Energy Efficient Ethernet 1000BASE-T LPI WAIT-QUIET Timer

IEEE P802.3az Task Force

Seoul, September 2008

From
IEEE802.3az
D0.9, Subclause
40.4.6.1, Figure
40-15b, p92.

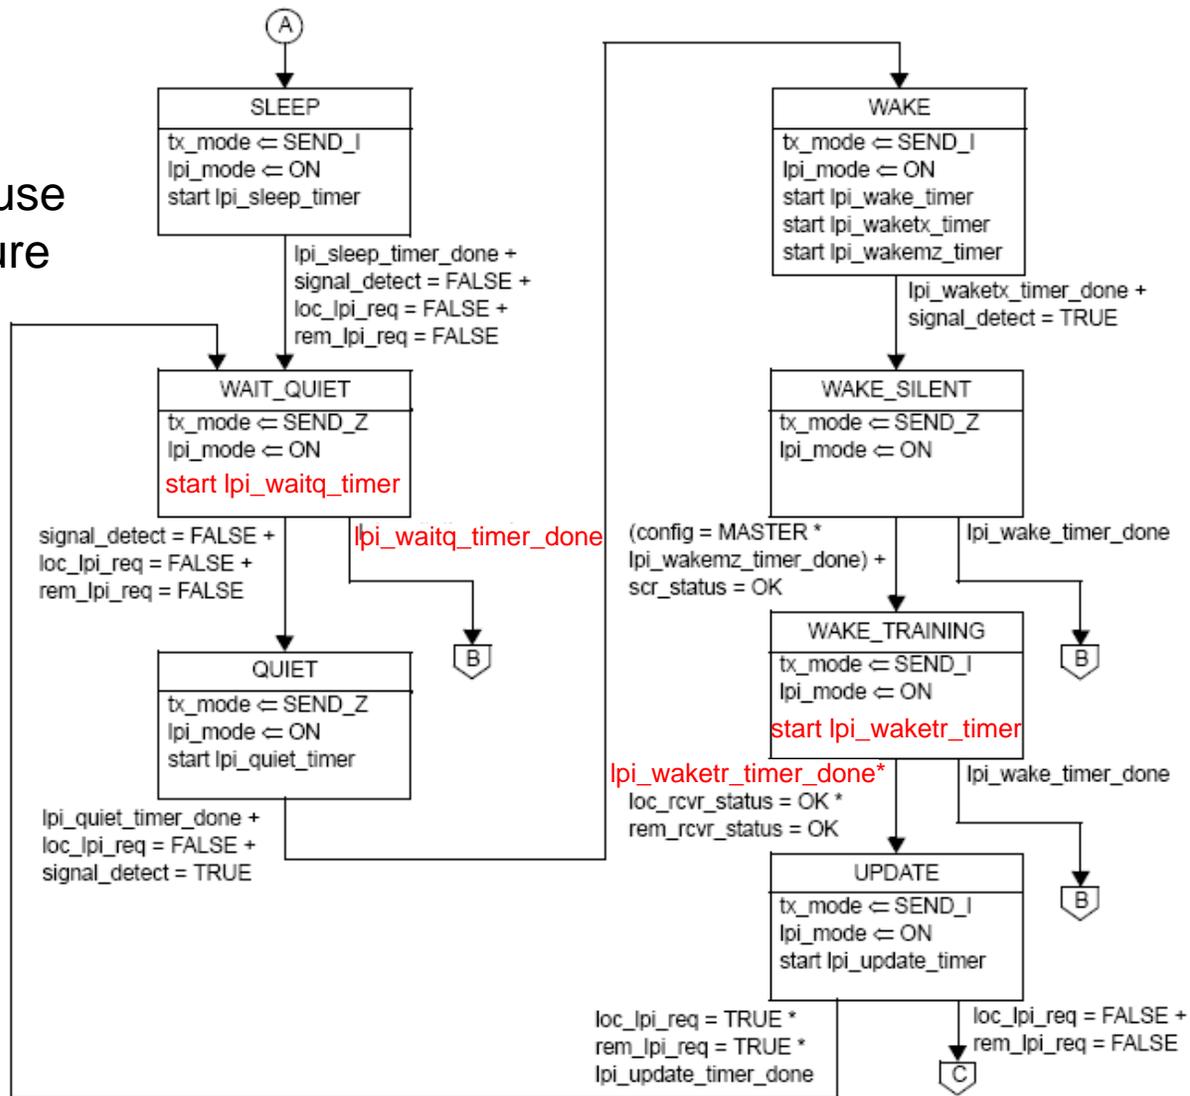
- IEEE 802.3az Draft 0.9 uses the timer, `lpi_wait_timer`, as an exit transition from both the `WAIT_QUIET` and `WAKE_TRAINING` states.
- In the `WAKE_TRAINING` state when the timer expires, there is a transition to `UPDATE` (normal wake procedure).
- In the `WAIT_QUIET` state, when the timer expires there is a transition to training.
 - Duration of timer is not sufficient to prevent retraining.
 - Extending the timer will increase the wake time.
- The presentation proposes replacing the `lpi_wait_timer` to two separate timers
 - `lpi_waitq_timer` – extend the value of `lpi_wait_timer` to provide margin and prevent an inadvertent retrain.
 - `lpi_waketr_timer` – keep the value of this the same as the `lpi_wait_timer`

- To avoid WAIT_QUIET transition to training, the following condition must be satisfied:
 - $2*(t1 + tp) + t2 + tw2 < lpi_wait_timer$
 - $2*(t1 + tp) + t2 + tw2 < 1.8 \text{ usec}$
 - Theoretically can be satisfied, but with very little margin.
 - Penalty against not satisfying is to retrain – unacceptable.
- Propose separating timer and adding additional margin to ensure that erroneous retraining events are avoided.

IEEE 802.3az D0.9, Subclause 40.4.5.2, pg 89, line 92, replace lpi_wait_timer (and its associated description) with the following:

lpi_waketr_timer

This timer defines the minimum time the PHY must remain in the WAKE_TRAINING state.

Values: The condition lpi_waketr_timer_done becomes true upon timer expiration.

Duration: This timer shall have a period between 1.8 μ s and 2.0 μ s.

lpi_waitq_timer

This timer defines the maximum time the PHY can dwell in the WAIT_QUIET state before retraining.

Values: The condition lpi_waketr_timer_done becomes true upon timer expiration.

Duration: This timer shall have a period between 4.5 μ s and 5.0 μ s.
